Subject: Calvert Cliffs Nuclear Power Plant
Units Nos. 1 & 2, Dockets Nos. 50-317 & 50-318
Evacuation Time Estimates

Calvert Cliffs Nuclear Power Plant
EPZ Evacuation Times

APPENDIX A-1

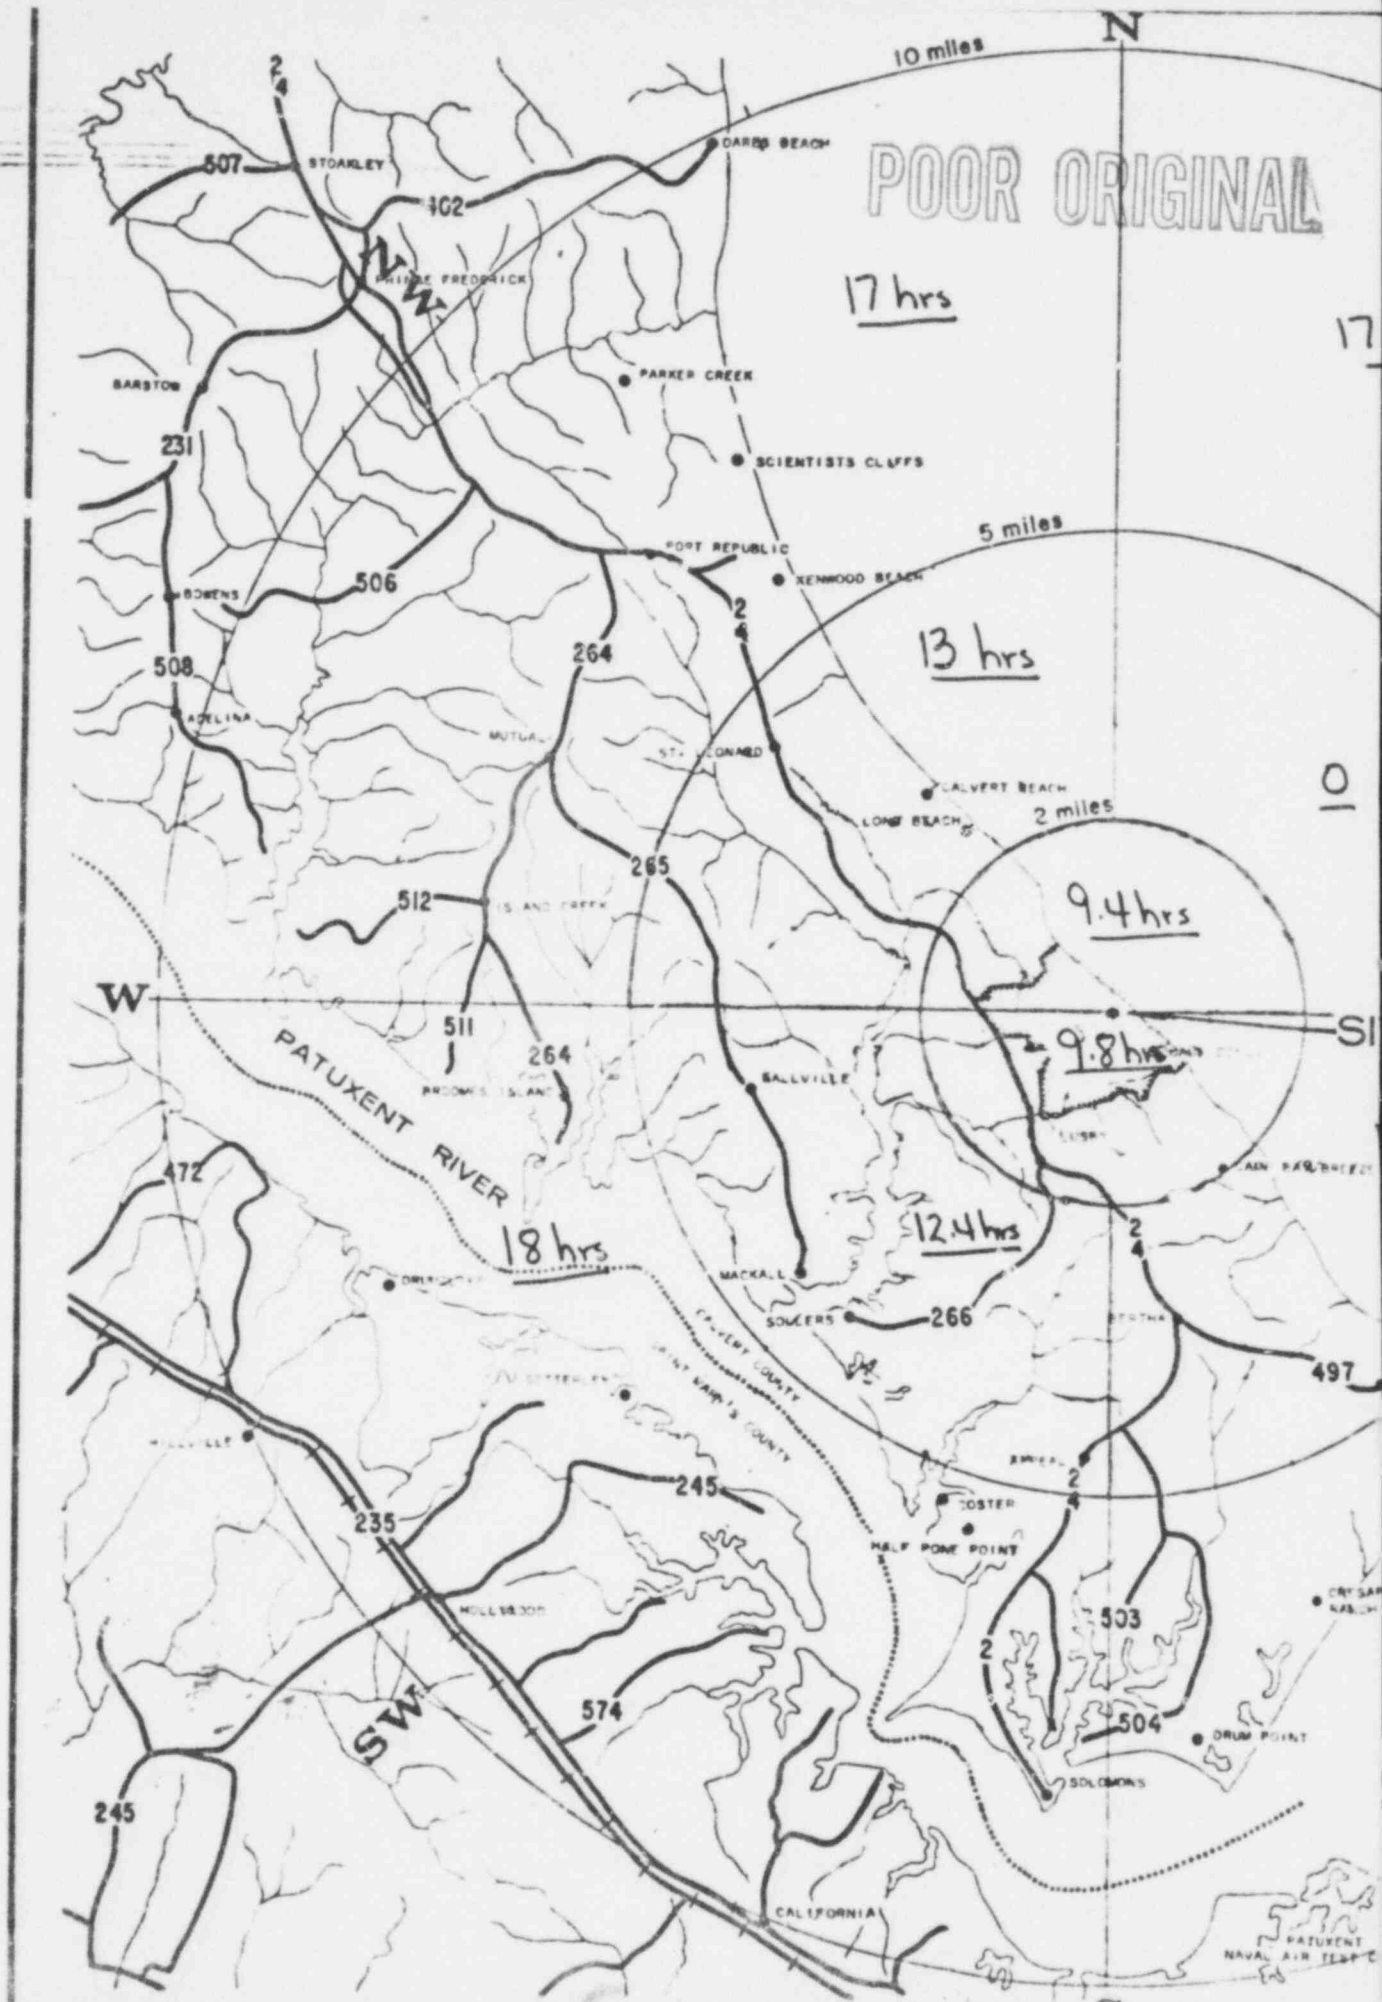
7. The map used should show the Columbia gas LNG facility, and should show the Johnson Bridge (Route 2) connecting the Calvert County and St. Mary's County.
